MS. Ref. No. essd-2021-201

“Median bed-material sediment particle size across rivers in the contiguous U.S.”

Dear editor and reviewers,

Figure R1: Box plots for the comparison of the ranges of 13 parameters between training data and all flowlines (i.e., NHD+).

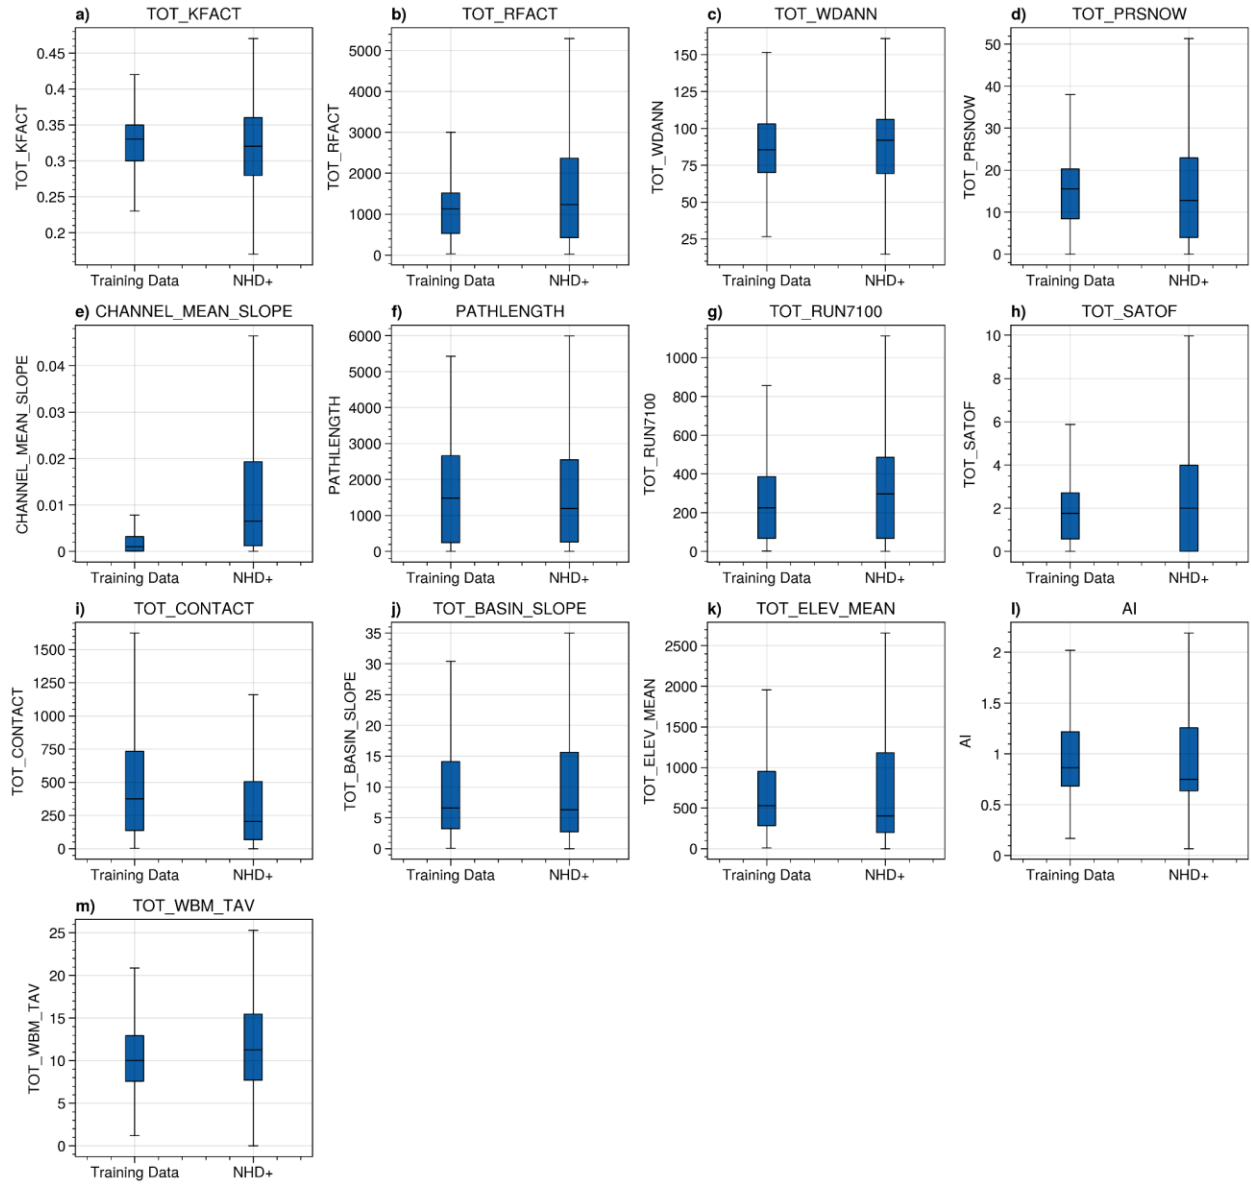
capability is constrained by the range of values present within the training data-set. Even if a trained model shows decent prediction capability for the testing data-set, there is no guarantee that the model will be able to predict correctly for cases that have input parameter values beyond the range of the training data. When the authors synthetically generated the data for the whole US using a model trained using (extremely sparse) 2577 spatial locations, they didn't mention about the range of values for the input parameters in the 26000 flowlines, which were later used to generate the synthetic dataset. I would recommend the authors to submit this paper to a different journal, e.g. WRR, Advances in Water Resources, Geoscientific Model Development, JGRE, etc., and increase the discussion about why the 13 parameters that SHAP value indicate to be the ones most responsible for determining the D50 of sediment at a stream location. As the above statement about the dataset suitability for the journal could be deemed subjective, I leave the final decision on suitability of the synthetically generated dataset for ESSD to the Editors. Going ahead, I will only comment on the technical and presentation issues of the paper. Please find detailed comments in the attached document.

We agree that “a ML model’s predictive capability is constrained by the range of values present within the training data-set”. First, per the reviewer’s suggestion, we have compared the ranges of the 13 input parameters between the training data and the nationwide data, as shown in Table R1. In Table R1, for each of the 13 features, we used the 2.5th and 97.5th percentiles to represent the lower and higher ends of ranges in the training data. We did not directly use the absolute min/max values to avoid the impacts of outliers. We then calculated the percentage of the nationwide data that is below the 2.5th percentile of the training data, and considered a percentage value no more than 10% indicates a good match of lower ends between the training and nationwide data. Similarly, we calculated the percentage of the nationwide data that is above the 97.5th percentile of the training data, and considered a percentage value no more than 10% indicates a good match of upper ends between the training and nationwide data. Taking together, for any feature, if more than 80% of the nationwide data are located within the 2.5th and 97.5th percentiles of the training data, we consider that the training data is sufficiently representative of the nationwide data for this specific feature. As shown in Table R1, for most features the percentages of the nationwide data that are beyond the lower or higher ends of the training data are no more than 10%, except for channel slope, i.e., “*CHANNEL_MEAN_SLOPE*”. Therefore, for 12 out of 13 features, the training data are representative of nationwide data.

of the nationwide data. This relative difference is less than 0.5 for most of the features, again except for “*CHANNEL_MEAN_SLOPE*”, further suggesting that the training data’s good representativeness of the nationwide data. For better visual illustration, Figure R1 below shows the box plots. Figure R2 shows the cumulative distribution functions (CDFs) and corresponding 5th-, 25th-, 50th-, 75th-, and 95th-percentiles. In addition, we would like to point out that the 1691 sampling stations we used to train and test our model are located across the whole contiguous U.S., hence geographically representative. Therefore, we conclude that the training data are representative enough of all the flowlines nationwide in terms of the 12 input parameters, except for “*CHANNEL_MEAN_SLOPE*”.

Figure R4: Spatial maps of the data in the histograms (Fig. 1b,c), i.e., sample count (upper panel) and latest sample year (lower panel).

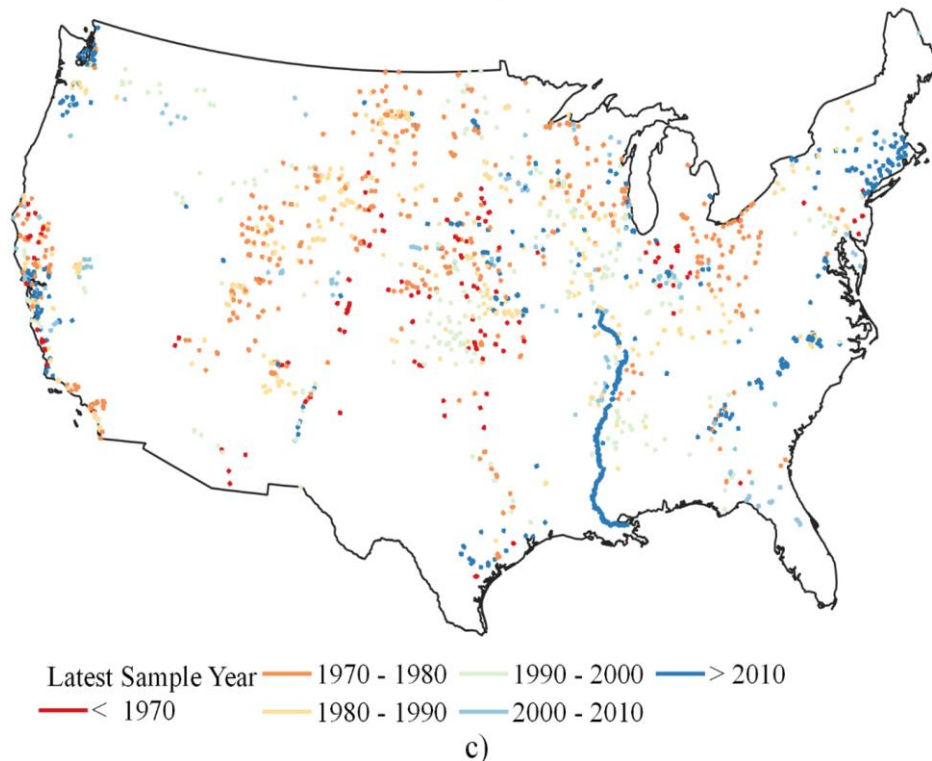
5) Please include more information in the caption of figure 1a, e.g. things like how many locations are actually shown on the map. Also, data that is shown as histograms (1b,c), could/should be represented spatially on the map. This would provide the readers additional information about the spatial variation of different aspects of the data.

Response: We have added the location information in the caption of Figure 1a, i.e., 300 red points from USACE and 2277 blue points from USGS. For the data shown as histograms (Fig. 1b,c), we also plotted the data used in the histograms spatially as the maps below (Figure R4).

Figure R5: Distribution of the coefficient of variation (CV) for the 760 stations that have at least 5 samples over time.

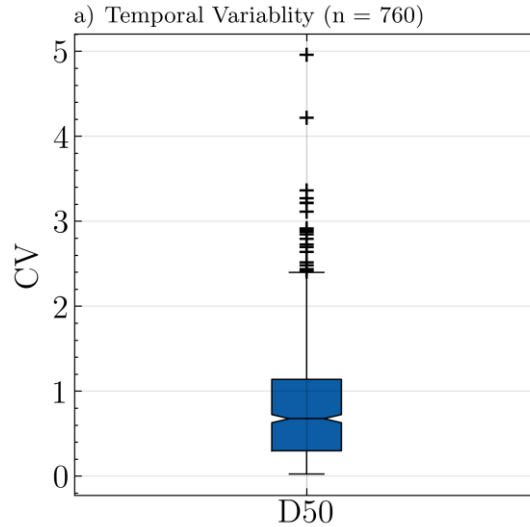
6) In all the locations that have multiple values of D50 reported in time, what is the variability in the D50 value over time? Even though the timescale across which the D50 data was collected is smaller than geomorphological timescales, it is important to check for the variability in order to be sure that the data was collected at stable stream-reaches. Also, what is the scientific basis for calculating a representative D50 by taking a mean?

Response: We calculated the coefficient of variation (CV) for the 760 stations that have at least 5 samples over time. For the rest of stations, the number of samples are too small for meaningful calculation of CV. Figure R5 shows that for most of these 760 stations the CV values range between 0.3 and 1.2 with the median of approximately 0.6. The small CV values indicate the good stability of D50 (at the same location) over time. We took the mean as a representative D50 to simply account for possible uncertainties in sampling and measurement. Although the sampling and measurement procedures were carefully designed (see Edwards and Glysson methods document <https://pubs.usgs.gov/twri/twri3-c2/>, as suggested by reviewer #2), it is practically impossible to avoid uncertainties in such sampling and measurement procedures. Thus, we believe a representative D50 can be better estimated by taking a mean.

Fig. R6: ML modeling using different objective functions.

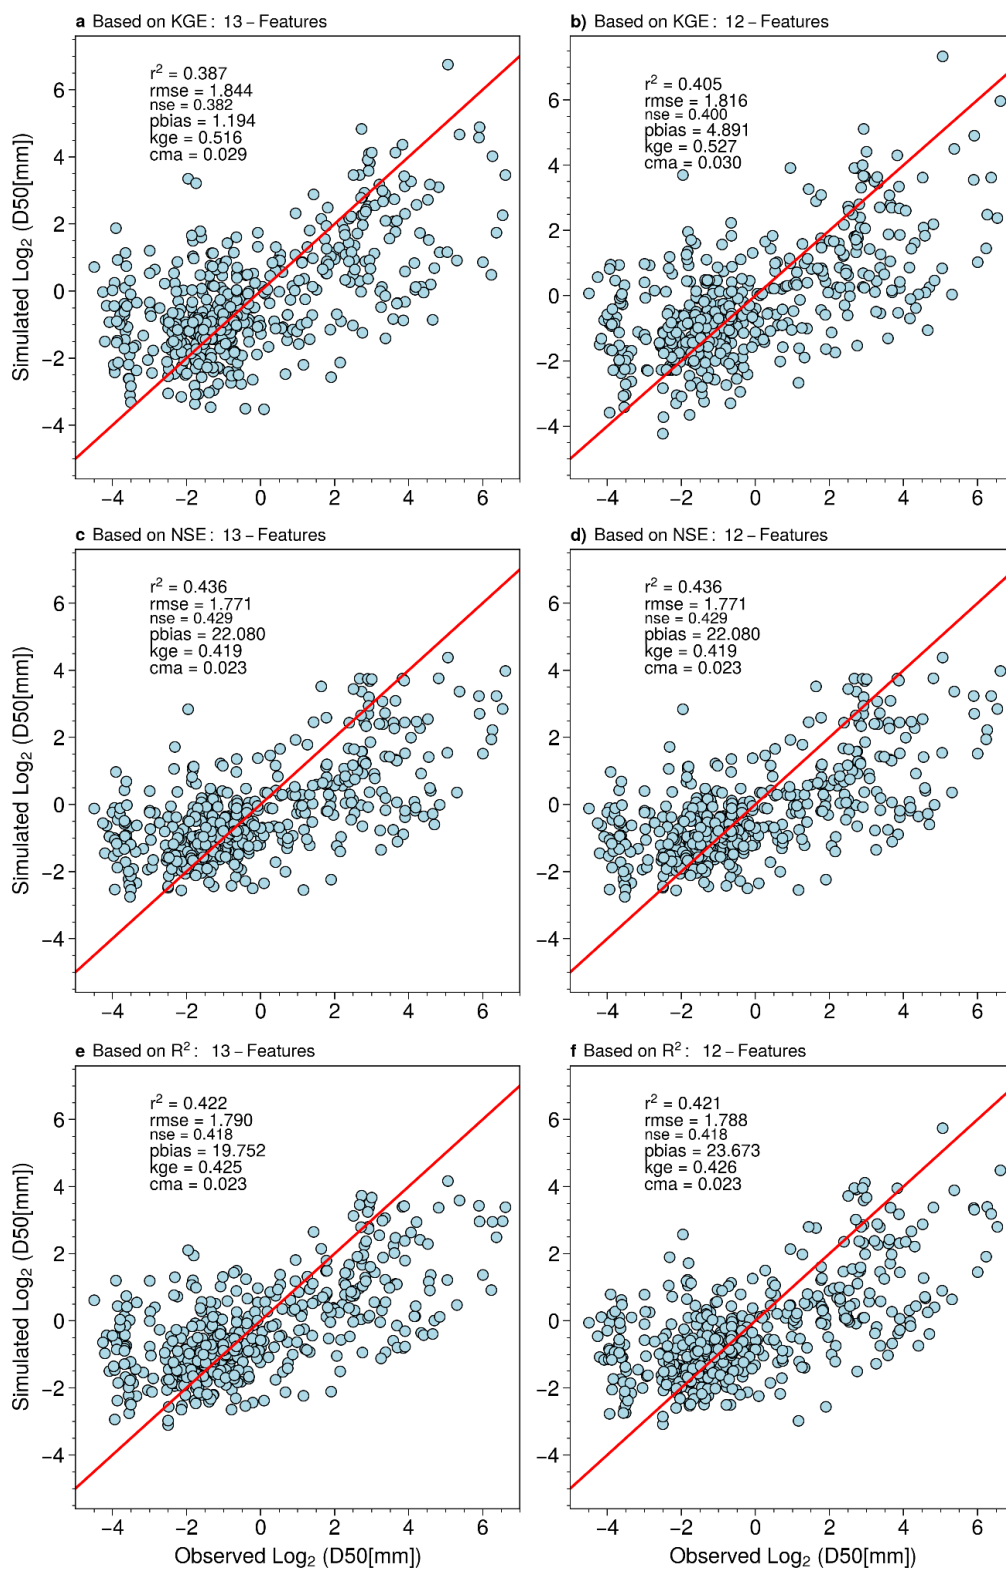
9) The use of KGE as the model performance parameter is interesting, especially as the KGE values for the testing dataset is relatively much better than the traditional R^2 . Though, KGE itself is fraught with issues (Onyutha, 2020). So it would be informative if the authors also provide model performance quantification using Nash-Sutcliffe efficiency, CMA (Onyutha, 2020), etc.

Response: In fact, we have used KGE, NSE and R^2 as the model performance parameters (hence objective functions). Based on a visual check of the patterns we obtained (see below Figure R6 and previous Figure R3), we feel that using KGE gives better patterns, i.e., the dots are more aligned with the 1:1 line as indicated by the percentage of bias (PBIAS). Per the reviewers' suggestion, we also added more metrics in the figure, including CMA.

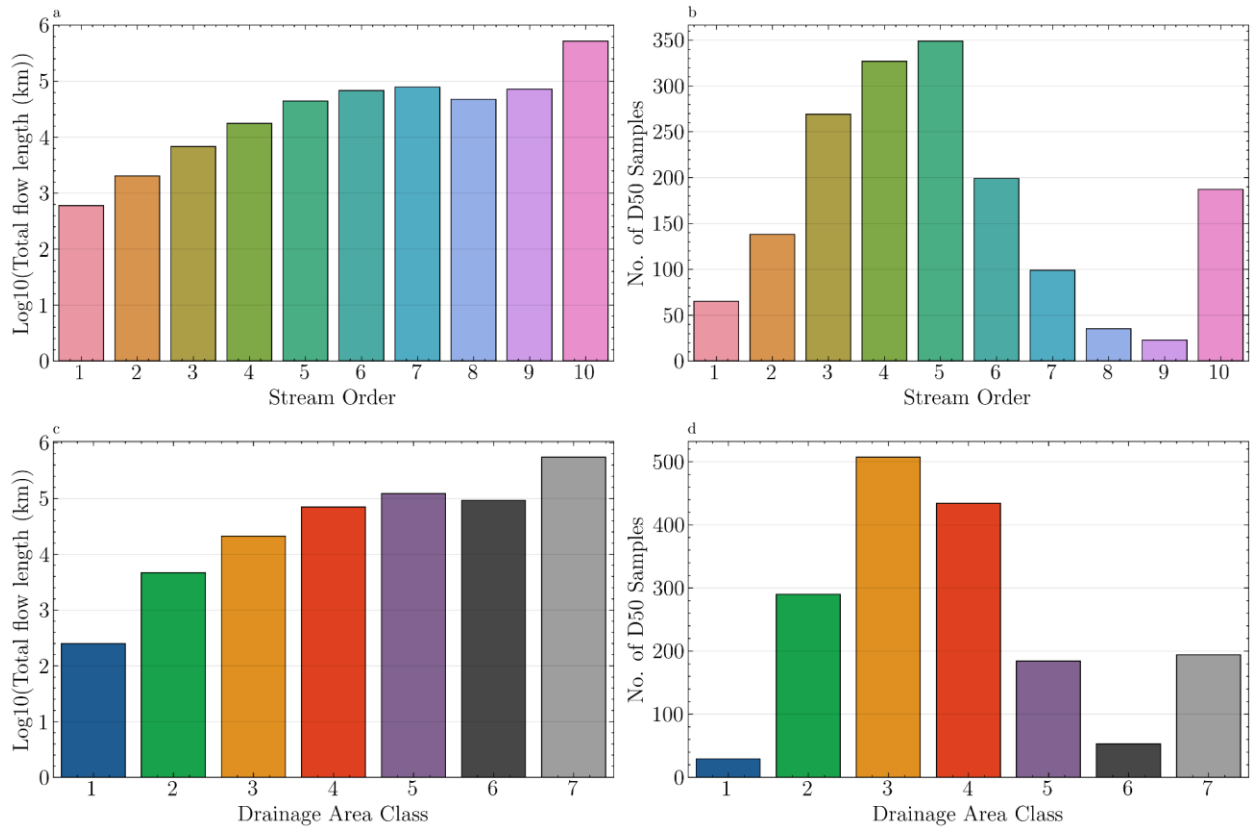
My biggest concern is that smaller streams may have more limited training data than exists for larger streams, and the D50 estimates for these smaller streams will involve greater uncertainty. This is based on the following: (a) a greater percentage of large streams are gaged by the USGS than small streams; (b) most of the data that does exist has D50 in the sand range – this suggests that smaller, steeper first and second order streams that are more likely to be gravel/cobble bedded are poorly represented in the data set, even though these smaller streams may dominate the total length of streams in the database. To clarify this issue as to whether my concern is founded, it would be helpful for the authors to provide a figure with two histograms for comparison: (1) a histogram that bins the stream database data according to stream size (x-axis) and analyzes total length of stream in each bin (y-axis); (2) a histogram that utilizes the same stream size (x-axis) bins and analyzes the number of D50 data points in each bin (y-axis). The variable chosen to represent stream size will need to be a surrogate such as upstream catchment area of the reach (*totdasqkm*) or stream order (*streamorde*) attributes. If that analysis confirms that my concern is founded, my recommendation will probably be that the analysis should be stratified into a dataset with higher confidence (larger streams) and a separate dataset with lower confidence (smaller streams).

Response: This is indeed a constructive comment. We plotted the histograms as the reviewer suggested (see Figure R7). For stream size, we quantified it using stream order (Fig. R7a,b) and upstream drainage area (Fig. R7c,d), respectively. Interestingly, smaller streams do not dominate total flowline length. Instead, the total flowline length of each stream order generally increases as stream size increases. The number of D50 stations follows a bell distribution except

for the largest stream order or drainage area, which is primarily due to the USACE measurements on the lower Mississippi River (198 sample locations). Therefore, there's no clear indication that the D50 data points are dominated by either larger or smaller streams. Our additional analysis here thus gives more confidence in the way the training data are treated in our study. In the revised manuscript, we will add some discussion on the possible impact of larger/smaller streams. We hope these additional analysis and discussion can satisfactorily address the reviewer's concern.
